Federal Communications Commission
Authorization and Evaluation Division

Subject: Class 2 Permissive Change V9MSM4NA0 for Radio Certification **for 3 products**

Applicant:	GRAUER Logan – Project Manager – UPONOR Inc
FCC ID:	V9MSM4NA0
IC ID:	7664A-SM4NA0
PMN:	SM4NA0
HMN:	A3801265, A3800161 and A3800169
HVIN:	P08172
FVIN:	V819 / PRG1697_VEB / PRG1393_VEB

Figure 1 : P08172

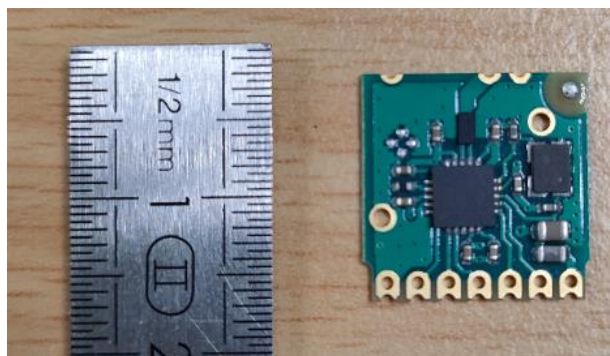
They all include P08172: PCB with radio transceiver CC110L chip and all electronic component to work with the same radio configuration except TX output power which has been changed to fit to radio requirements.
